U.S. Department of Energy · Office of Environmental Management

Technical Assistance Report
Evaluation of Proposed Modular
Waste Water Treatment Plant

November 21, 2002

The Office of Science and Technology (EM-50)
Technical Assistance Team

Figure 1: Current Wastewater Flow Management System

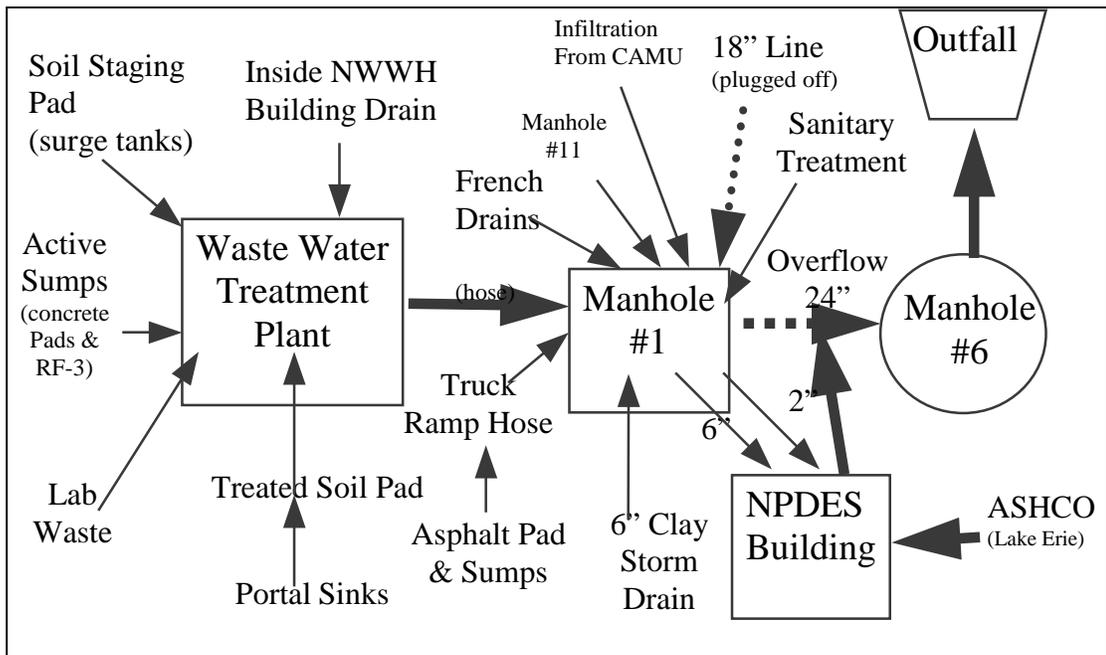
A simple line diagram of current sources and destinations of wastewater, presented in Figure 1 below, was prepared to aid in the evaluation of current and future WWTP requirements. The diagram shows sources coming from the west side of the site on the left side of the chart that are treated in the WWTP¹. Wastewater sources being treated in the wastewater treatment plant principally originate from rainfall on the soil staging cleaning pad, transfer from active sumps associated with concrete pads and RF-3, as well as small quantities of analytical laboratory water and portal sinks. Water from the truck ramp is sampled prior to transfer to Manhole #1. If treatment is required, this wastewater is transferred to the WWTP for treatment. If treatment is not required, this wastewater is transferred directly to Manhole #1.

The volume of water sent to the WWTP is dominated by contaminated water that has fallen on contaminated pads and is collected. This volume is expected to be reduced as the surface areas of contaminated pads are reduced. The wastewater treatment plant processes batches of approximately 8000 gallons that are sampled for compliance, sent by hose to Manhole #1, then to flow augmentation and discharge to Manhole #6 as shown on the right side of the diagram. (Note: Treated wastewater transfer was originally accomplished using the buried 18" line that has since been plugged because of infiltration of TCE from the CAMU.)

Other sources of wastewater that originate on the east side of the site may go directly to Manhole #1. Infiltration water containing TCE that originates in the CAMU appears to be following the 18" line to Manhole #1 where it currently can be sent through to discharge. Contaminated water from the French drains from the soil piles contains uranium contamination also currently goes directly to Manhole #1. At this time it appears to be impossible to quantify the magnitude of the impacts from these streams because flow and concentration data have not been correlated. Thus, the infiltrating TCE water and soil pile uranium wastewater sources are included in the areas requiring better characterization data.

Permitted flow augmentation using Lake Erie water from ASHCO occurs in the NPDES building. Flow augmentation ratios ranging from 3-1 to 7-1 are used on wastewater transferred by a 2" line (~45 GPM) from Manhole #1. This augmented wastewater is sent to Manhole #6 where it flows to the outfall. Water from significant rain events can either be pumped via a 6" line (~500 GPM) or overflow directly from Manhole #1 to Manhole #6, bypassing the flow augmentation process at the NPDES building.
